ADDENDUM NO. 1

**HANOVER COMMUNITY SCHOOL CORPORATION - NEW RESOURCE
CENTER AND RELATED WORK
Cedar Lake, IN 46303**

This Addendum consists of page ADD 1-1 and attached Addendum No. 1 from Gibraltar Design dated May 27, 2021 and consisting of 5 pages and 48 drawings.

SCALE: 3/16" = 1'-0"

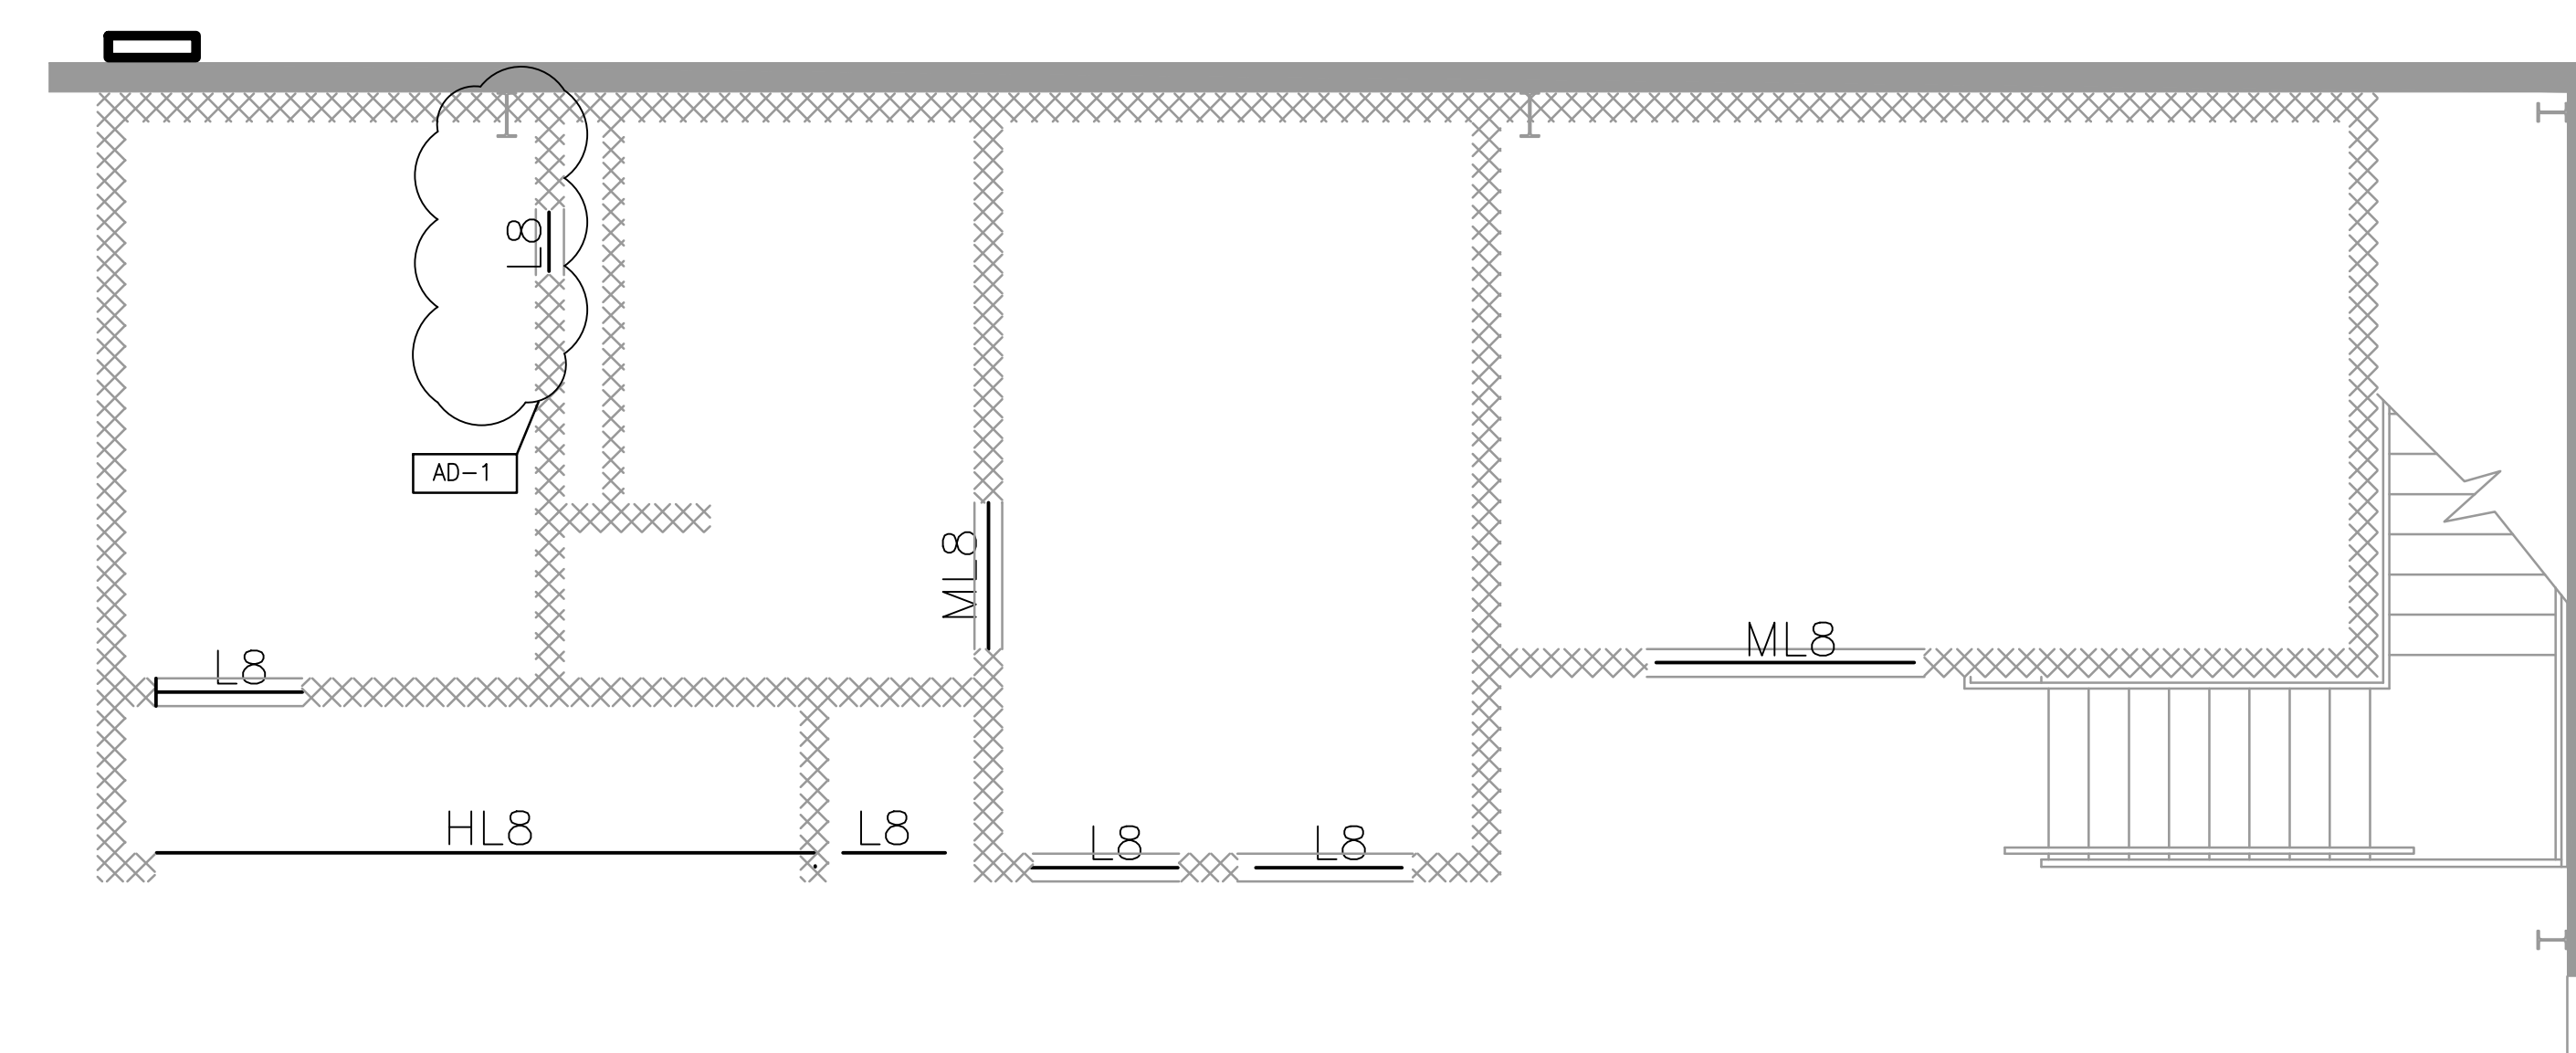
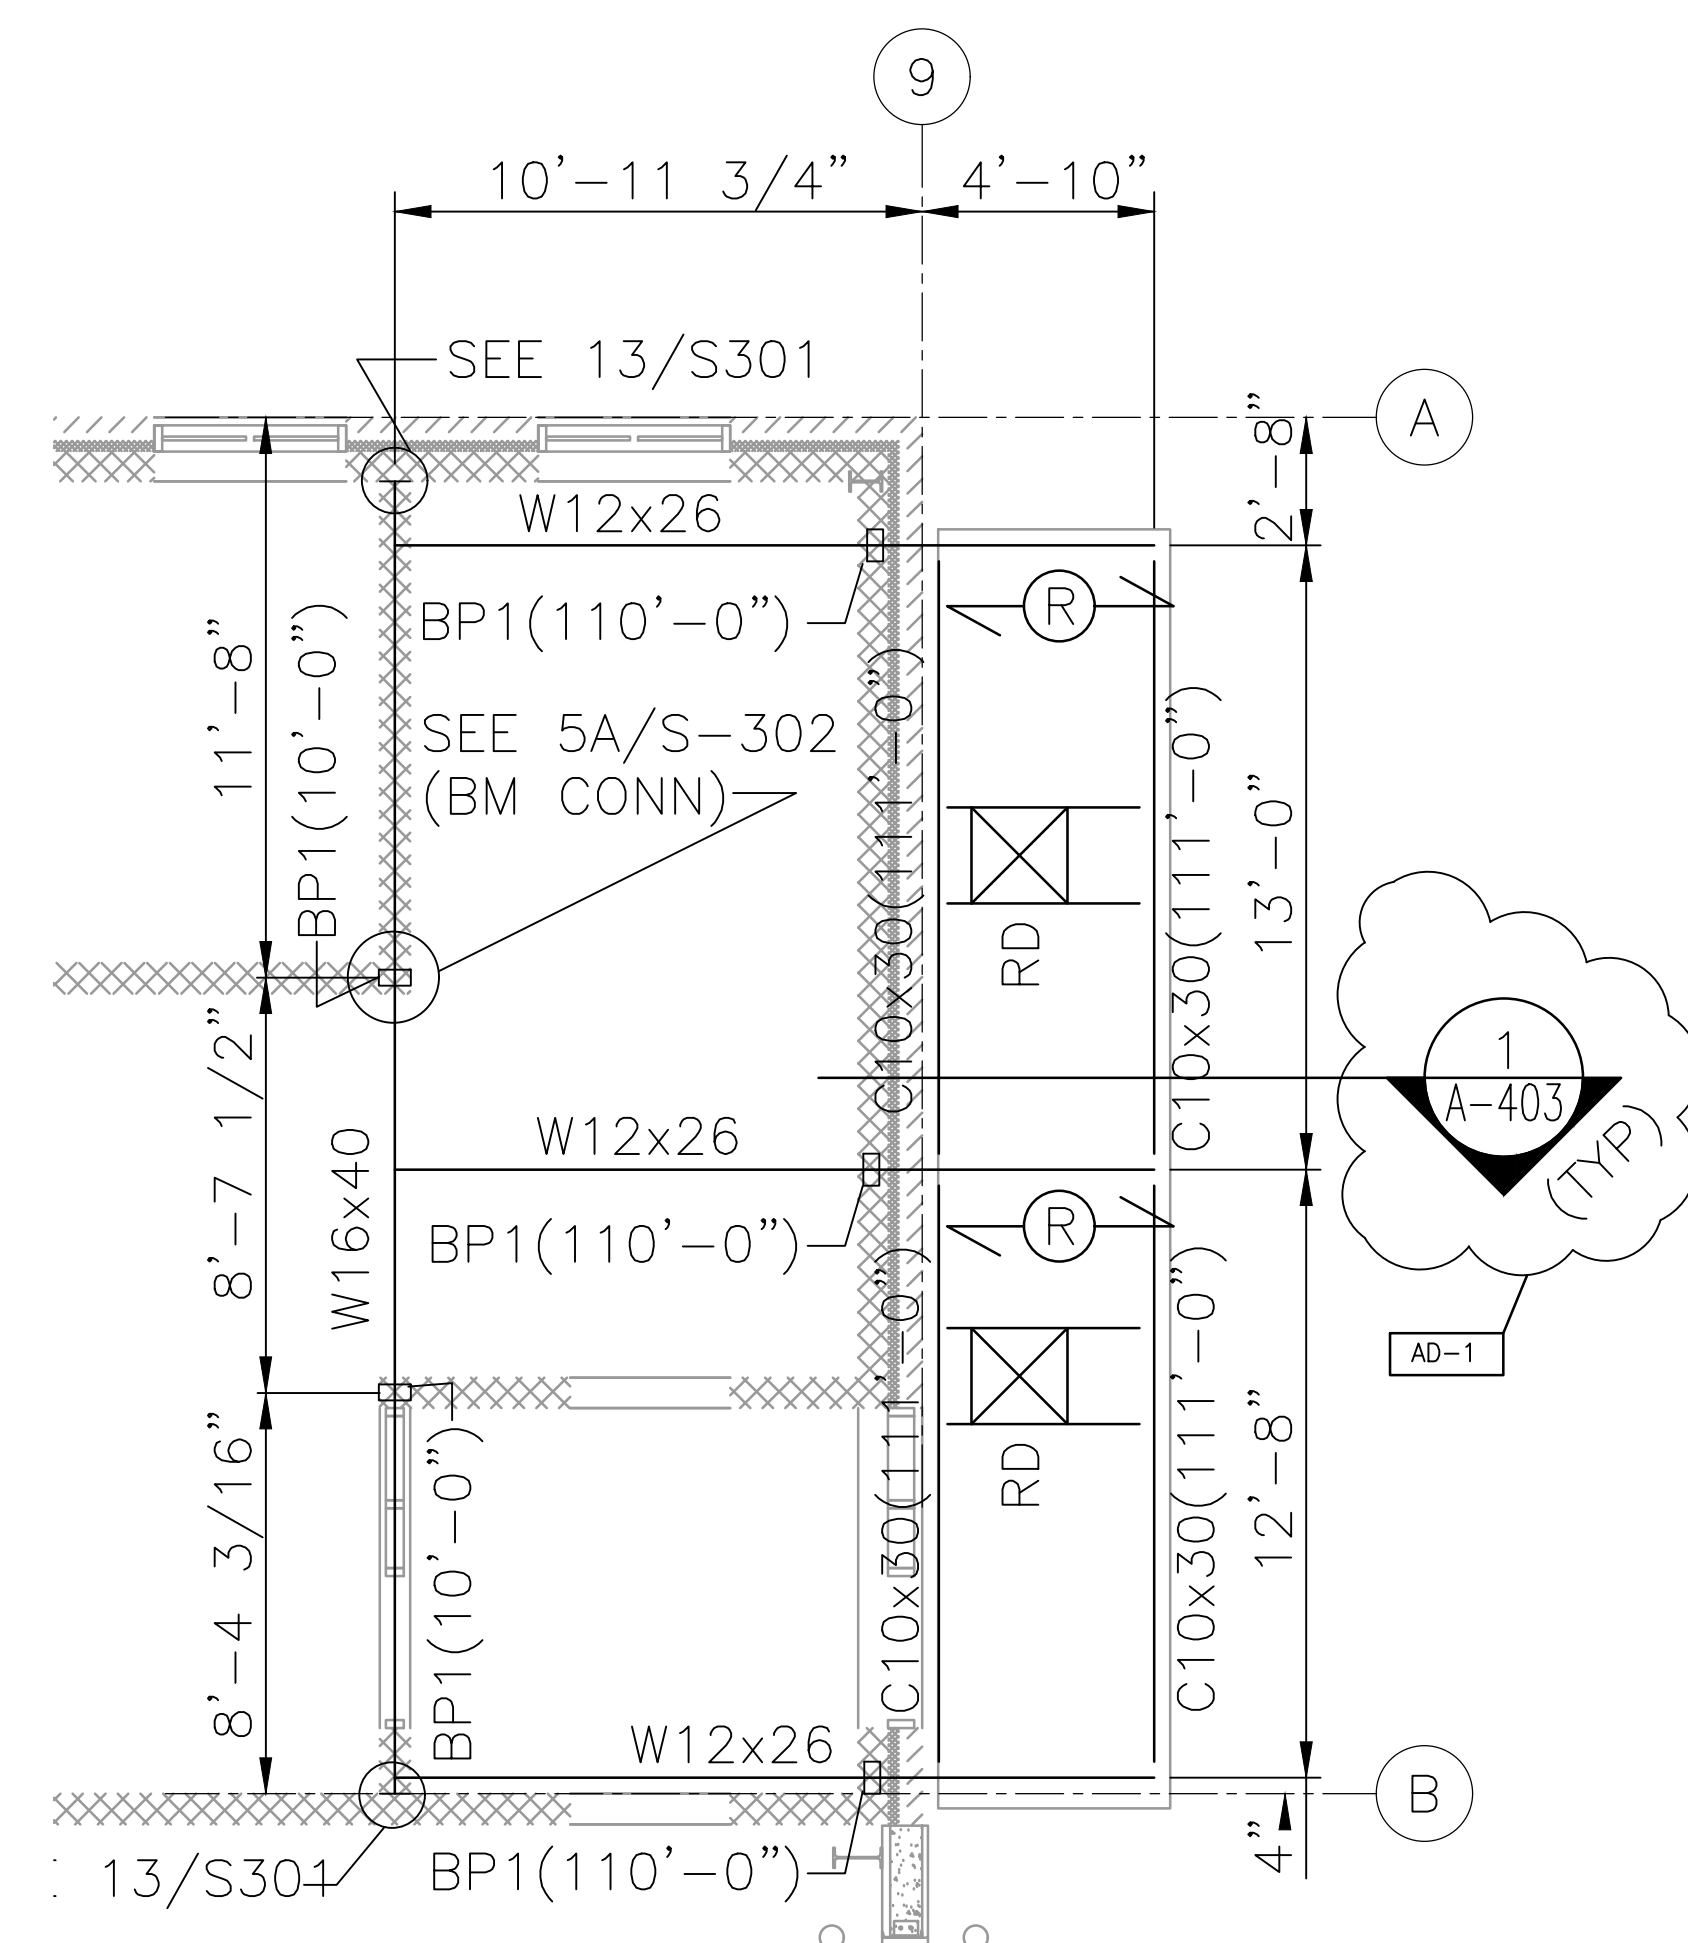
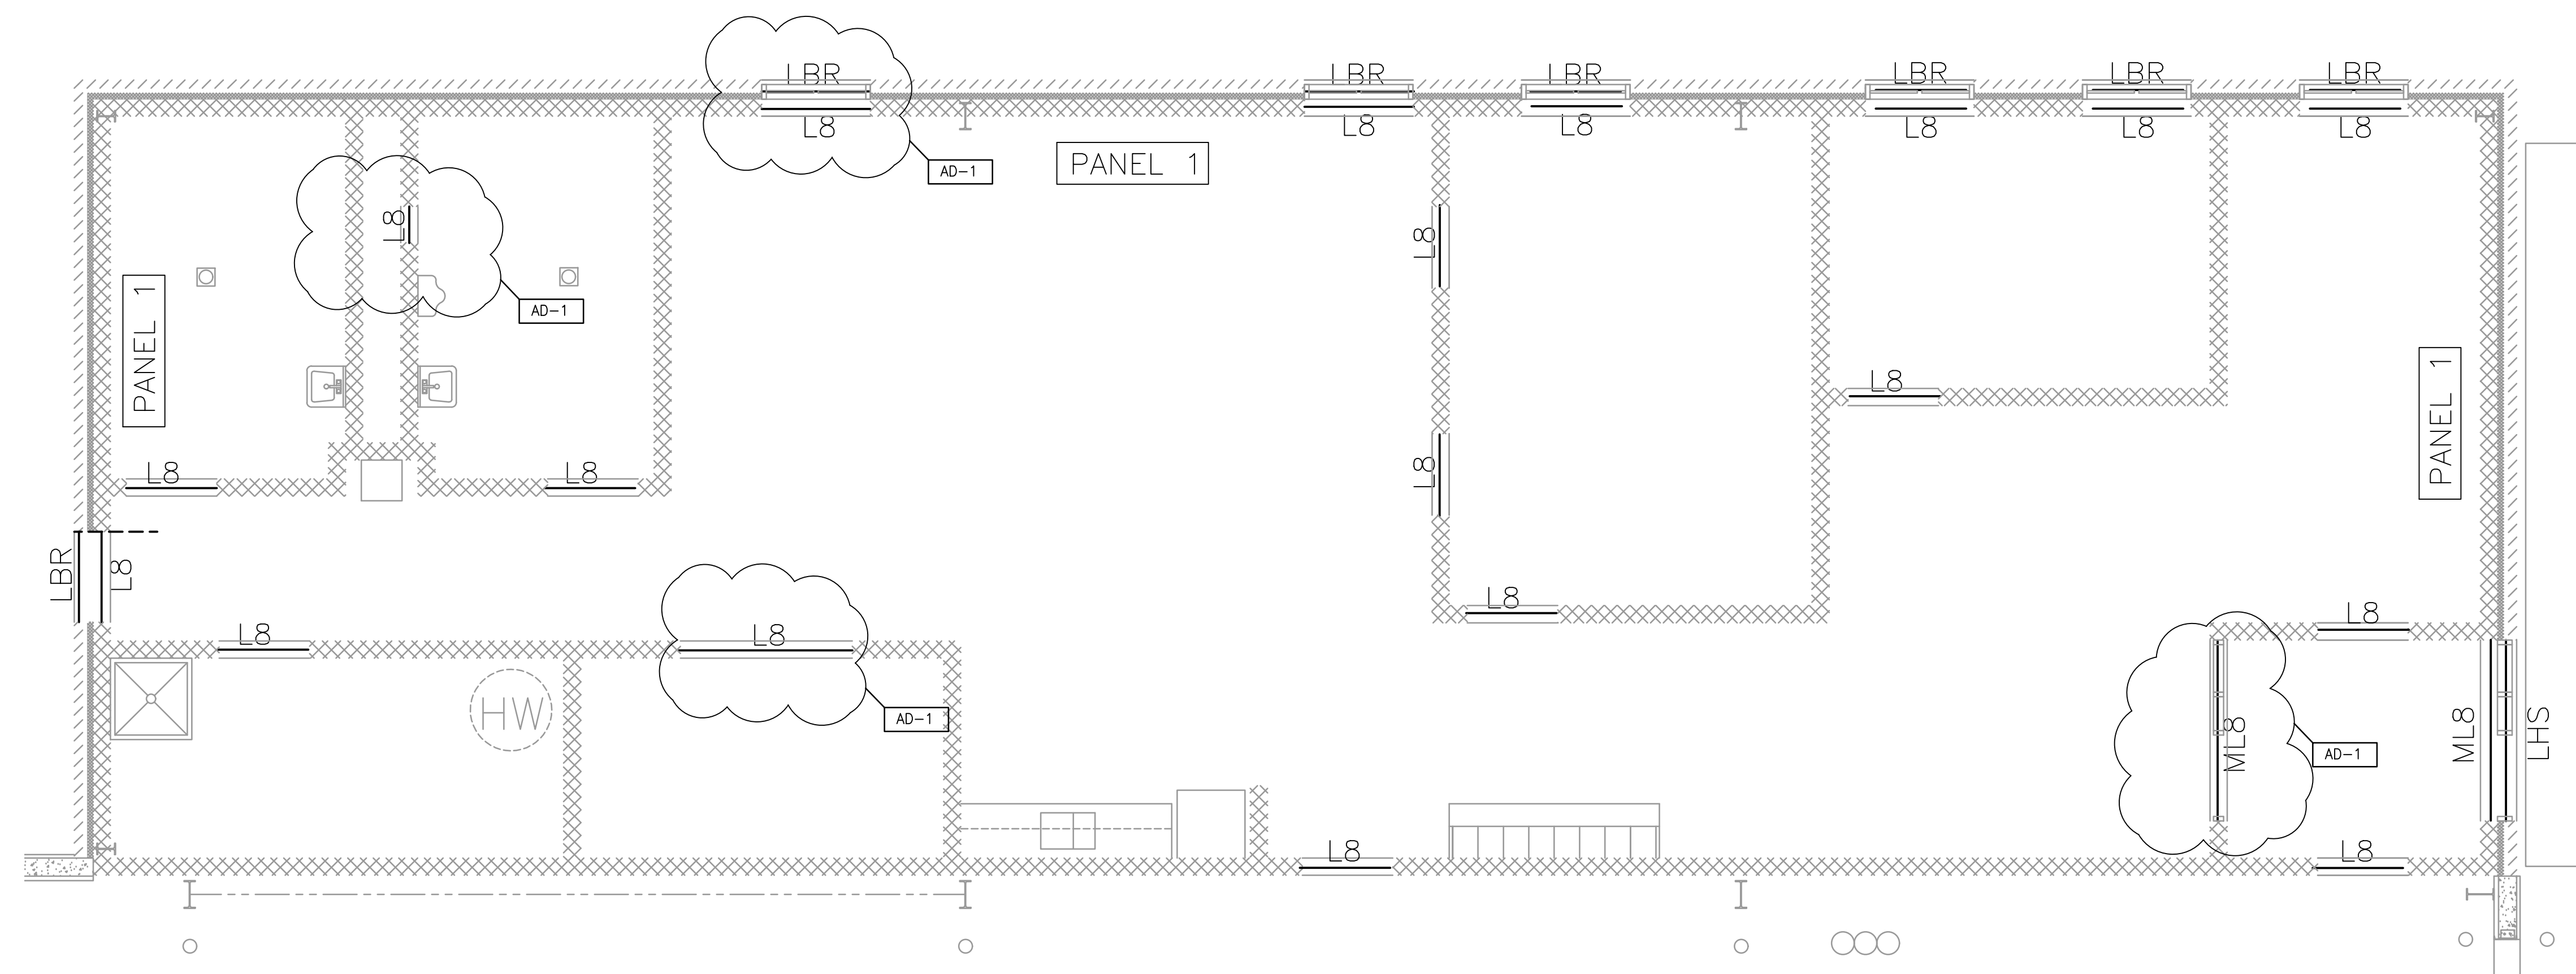
7. Sheet LB101

1. Revise section cuts layout for Resource Center Building – (3) Canopy Framing Plans.
2. Revise section cut label for “Maintenance Building – Lintel Plan” and Bus Garage Building – Canopy Roof Framing Plan”.
3. Revise lintel plan layout for “Bus Garage Building – Lintel Plan”.
